Drawing revised by HGP in areas to indicate proposed amendments

Date	Feb 2021
Drawn By/Checked By	RW/VC
Scale	1:500@A1
Revision	**P4**
Project	**Kingston Wharf Brighton**
Title	**Proposed Context Elevations**
Dwg #	**20086-HGP-PL-500**
Status	**PLANNING**

1 PROPOSED NORTH ELEVATION
1 : 500

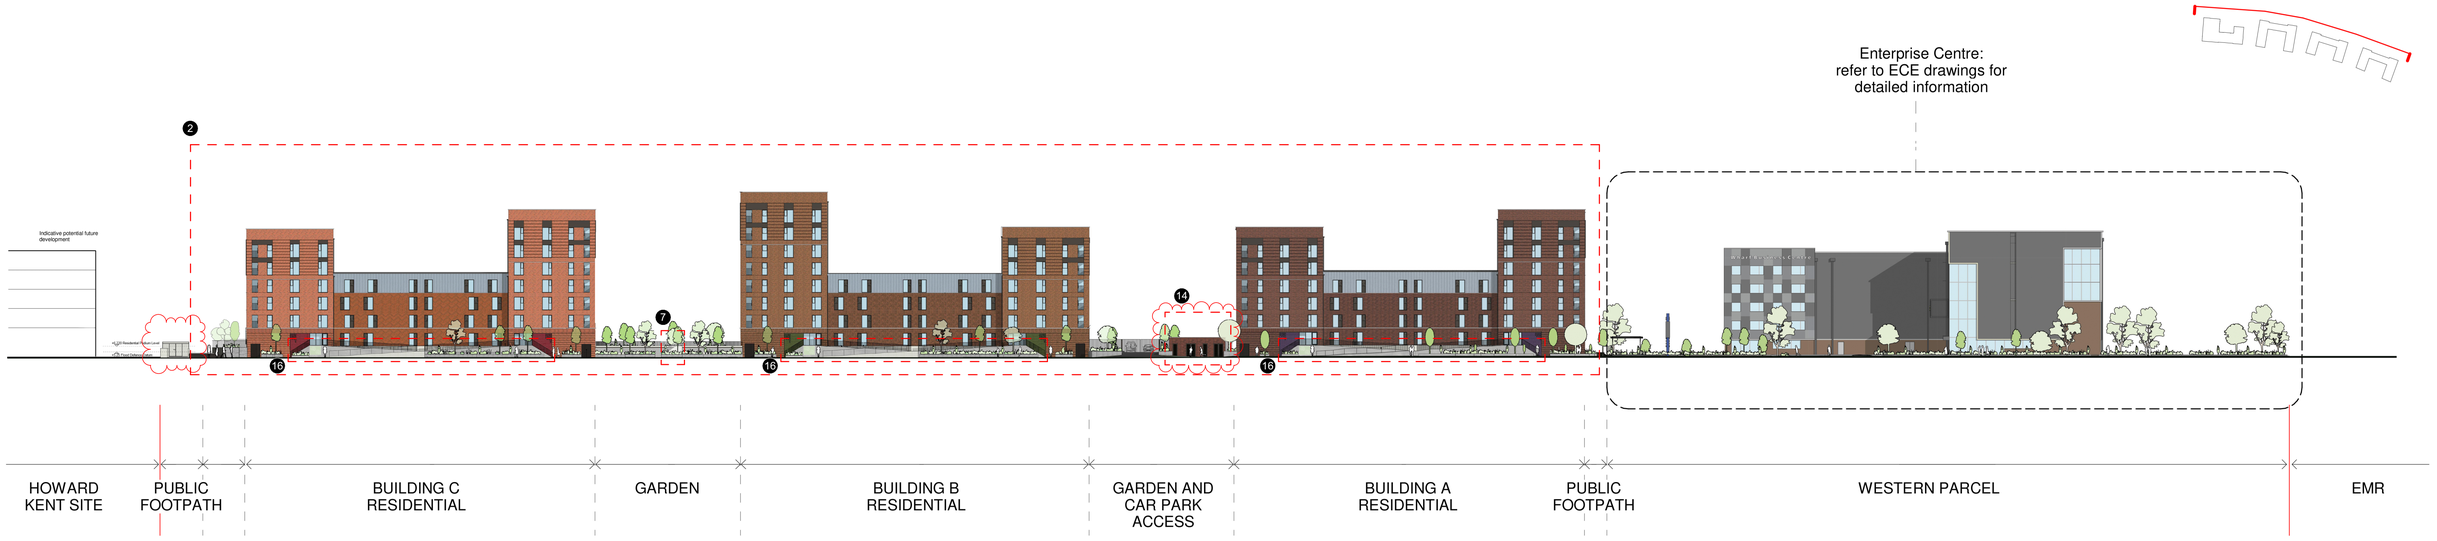
1 Levels amended to suit reduction in building height.

2 Building height reduced and basement raised out of tidal zone to mitigate the risk of flooding.

3 Brick piers introduced to provide secure junction to window & baustrade fixing.

4 Window positions revised to suit structural requirements.

5 Windows replaced with tax windows to meet fire strategy compliance.

6 Ventilation grilles removed to avoid sea water exposure to basement.
